Docket Item #14
CDD CONCEPT PLAN AMENDMENT #2007-0001
POTOMAC YARD/POTOMAC GREENS

Planning Commission Meeting
December 4, 2007

ISSUE: Consideration of a request to amend conditions of the CDD concept development plan approval for Potomac Yard.

Figure 3. Proposed Pedestrian Bridge at WMATA Reservation Area

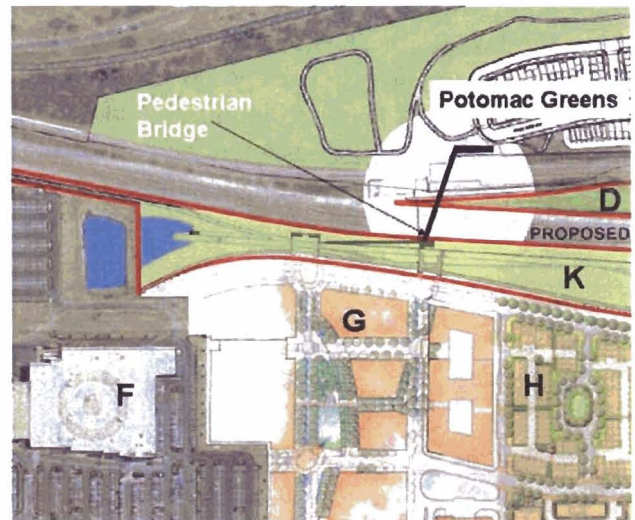
The applicant proposes to locate the pedestrian bridge at the north end of Potomac Greens and Rail Park, at an existing WMATA Metro Station reservation area. The bridge, which will span approximately 250 feet over the heavy rail and the WMATA Metro train tracks, will provide the pedestrian connectivity to the east and west portions of the Yard. This is a logical location for the bridge because it links several community amenities such as the wetland/trail north of Potomac Greens on the east side of the tracks to Landbay K, the regional linear park on the west side of the tracks, and to the Town Center (Landbay G), where the highest density of development is expected, and where there is the greatest concentration of retail. The bridge would be designed to accommodate a possible touch

down at Rail Park if one is requested by the community in the future public process for Rail Park. The bridge could also be designed and located to coexist with a potential Metro Station at this location in the future. The bridge landings will be located at an area in Potomac Greens that is currently reserved for the WMATA Metro station and in Landbay K, the linear park in the west half of Potomac Yard (See Figure 3, Pedestrian Bridge at WMATA Reservation Area).

While staff believes the proposed location is a reasonable location, staff also acknowledges that additional time is needed to work with the adjoining community groups and PYDAC. However, if the trigger condition is not amended, the applicant will be in violation of this condition. Therefore, staff is recommending that the trigger be amended to allow some additional time to work with the appropriate groups, however, require submission of a plan by March 2008. In addition, staff is recommending that the bridge commence construction prior to the approval of Landbay I and/or J, which staff estimates will be Fall of 2008. The condition proposed by staff also states that if a location has not been selected by October 2008, the applicant would be permitted to make a monetary payment equivalent to the amount necessary to design and construct the bridge.

- (p) Pedestrian Bridge across rail tracks-- ~~Construction shall commence within 30 days of final site plan approval for 1,000,000 square feet of new development within the CDD (including development consisting of interim, permitted and special uses), for which final site plan approval has been given after the date of concept plan approval, and shall thereafter be diligently pursued to completion.~~ **Potomac Yard Development LLC ("PYD"), or its successors, shall submit the pedestrian bridge design and location and all applicable documents for the pedestrian bridge across the WMATA and CSX rail tracks by March 1, 2008. The design of the pedestrian bridge shall be in consultation with the Potomac Yard Design Advisory Committee and the Park and Recreation Commission. The bridge design and location for the pedestrian bridge shall require review and approval by the Planning Commission and City Council. Construction of the pedestrian bridge shall commence prior to preliminary site plan approval for any development in Landbay I or J, except for the 10 units already approved in Landbay I pursuant to DSUP# 2004-0048. If the City has not approved the bridge design and location for the pedestrian bridge prior to October 31, 2008, PYD, or its successors, shall make a monetary payment including a reasonable cost escalation clause to the City equivalent to the design, construction and all applicable costs of the pedestrian bridge, such costs shall be mutually agreed upon by the City and PYD. The monetary payment shall be**

Figure 4. Rail Park Contextual Aerial

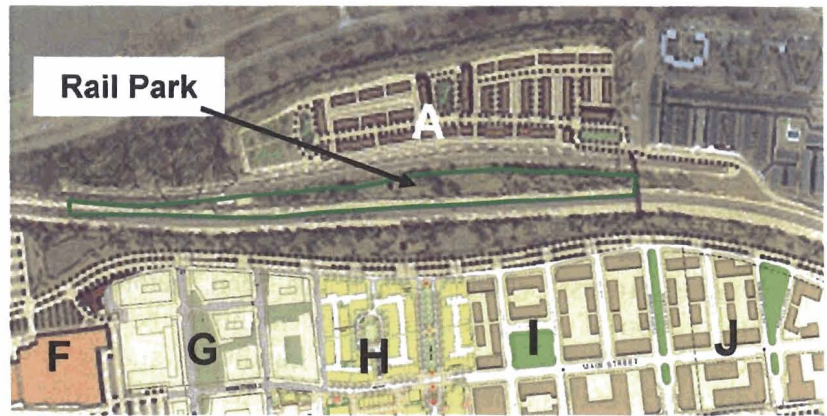
CDD condition 15 (r) refers to the construction timing for Rail Park. The CDD requires Rail Park to be completed in conjunction with Potomac Greens (Landbay A). The first time Planning Commission considered Potomac Greens for preliminary plan approval, staff also submitted the Rail Park preliminary plan for Commission

consideration. However, the Planning Commission tabled the Rail Park approval, and City Council noted the deferral without objection at their March 15, 2003 hearing. City Council approved Potomac Greens on May 17, 2003. Potomac Greens is under construction, with approximately two-thirds of its townhouse units occupied. The CDD and Design Guidelines specify that the uses for Rail Park include a community garden, tennis or volleyball courts, exercise stations and a dog run area.

The community was divided on the dog park in Rail Park and the Planning Commission requested staff to further study the feasibility of the proposal for Rail Park.

Rail Park ----- ~~Construction, including only the planting of a ground cover acceptable to the Director of Recreation, Parks and Cultural Affairs, on the northern 1.2 acres of this park, shall occur in conjunction with the development of landbay "A," and shall be completed by the date or event described in the initial preliminary development plan approval for this landbay Potomac Yard Development LLC, ("PYD"), shall construct or dedicate Rail Park – at the City's option, prior to the issuance of a certificate of occupancy for any future development in Landbay I or J, except for the 10 units in Landbay I already approved pursuant to DSUP#2004-0048. PYD or its successors, shall submit a proposal for rail park plan or an alternative off-site dog park plan in another landbay consistent with the intent of the Potomac Yard Urban Design Guidelines with and all applicable documentation for rail park prior to March 1, 2008. The rail park plan proposal shall require review and approval by the Planning Commission and City Council. Construction of the rail park approved plan shall commence prior to preliminary site plan approval for any future development in Landbay I or J, except for the 10 units in Landbay I already approved pursuant to DSUP#2004-0048. If the City has not approved the rail park plan proposal prior to October 31, 2008, PYD, or its successors,~~

shall make a monetary payment including a reasonable cost escalation clause to the City equivalent to the design, construction and all applicable costs of the improvements to Rail Park as described in the Potomac Yard Urban Design Guidelines, such cost shall be mutually agreed upon by the City and PYD. The monetary payment shall be made prior to preliminary site plan approval for any future development in Landbay I or J, except for the 10 units already approved in Landbay I pursuant to DSUP#2004-0048. (PC)

Figure 5. Open Space in Landbay L

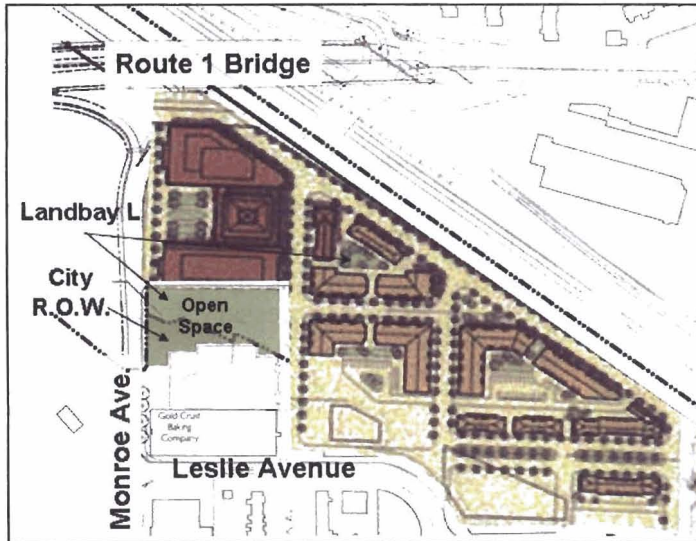
The applicant proposes to dedicate Rail Park to the City and dedicate and improve the open space in Landbay L adjacent to Monroe Avenue. The area, proposed to be set aside at Monroe Avenue, across Simpson Fields, would have a cumulative size of approximately 0.9 acre. The

area is a combination of 0.66 acre of land in Landbay L and 0.25 acre of the Monroe Bridge right-of-way that will be vacated when the new Route 1 Bridge opens. The 0.66 acre in Landbay L would be part of the developer's dedicated open space requirements for Landbay L. The programming of Rail Park and the proposed open space is to be left open for additional community input and subsequent Planning Commission and City Council review and approval.
